CASE 13-T-0469

**DPS Staff Interrogatories DPS-001 to DPS-027 with
Central Hudson responses.**

Central Hudson Gas and Electric Corporation

**A&C REBUILD PROJECT - ARTICLE VII APPLICATION
Case 13-T-0469**

"M" AND EXISTING "C" LINE SHARED R.O.W.

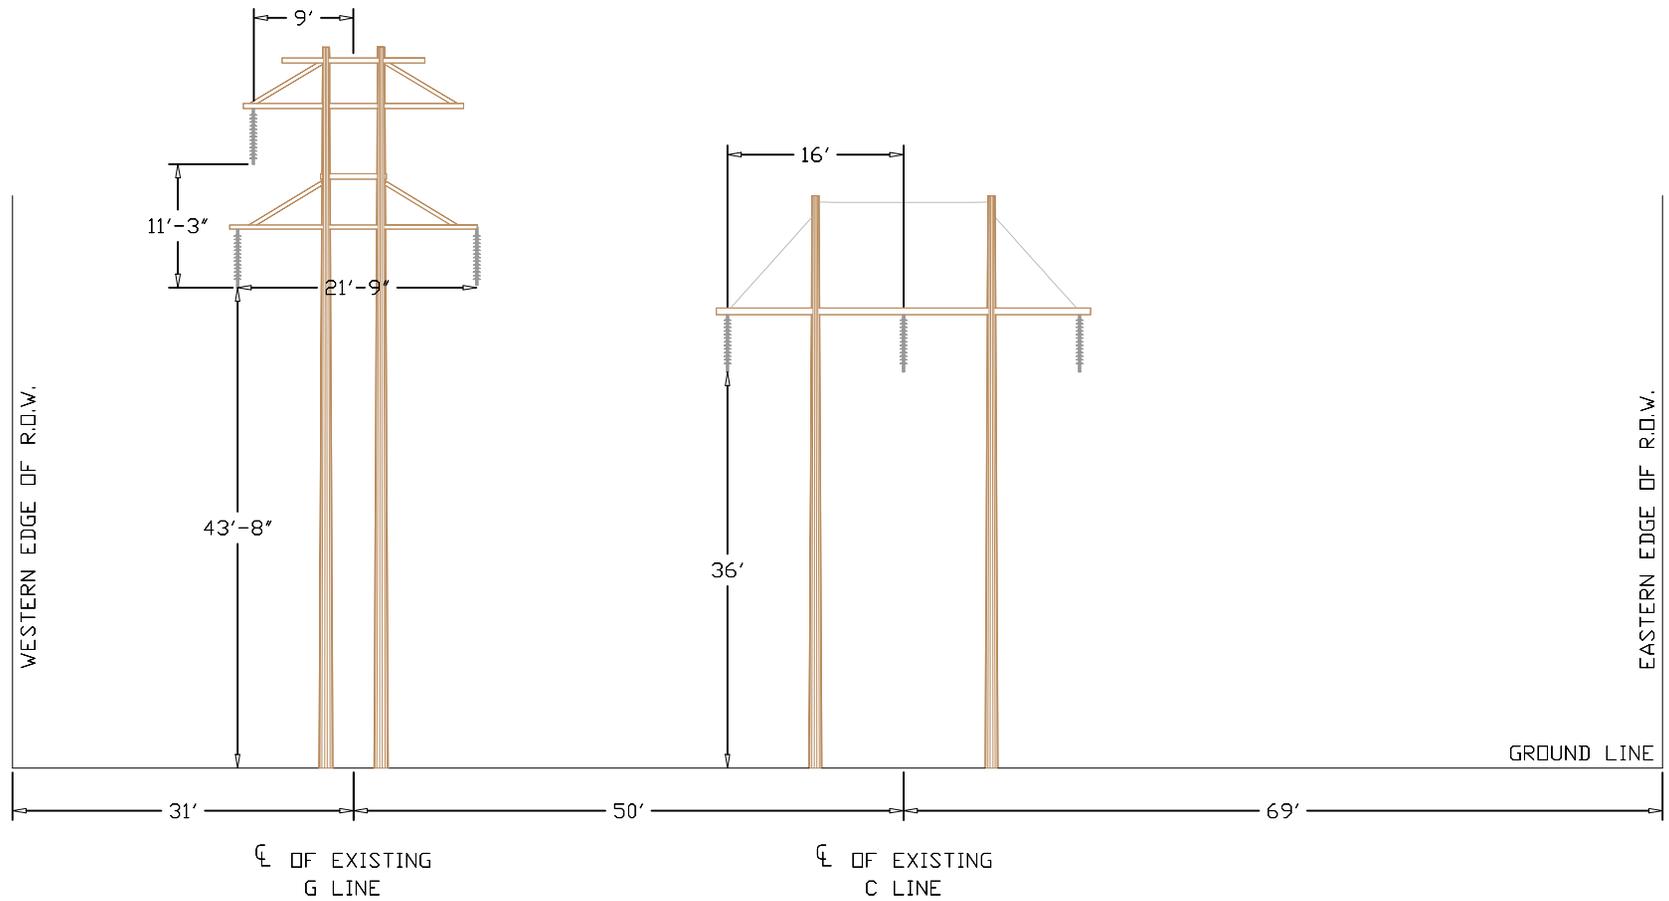
Provide the engineering drawings for the Consolidated Edison-owned lines and the Central Hudson Gas and Electric Corporation-owned A&C lines used to calculate the EMF levels that were provided in the Application for various portions of the right-of-way (ROW). The drawings should be to scale and include the dimensions of the structure and spacing of the conductors and ground wires.

The drawings used to calculate the EMF levels are the cross-sections (8 sheets) attached as **Exhibit A** to this Response.
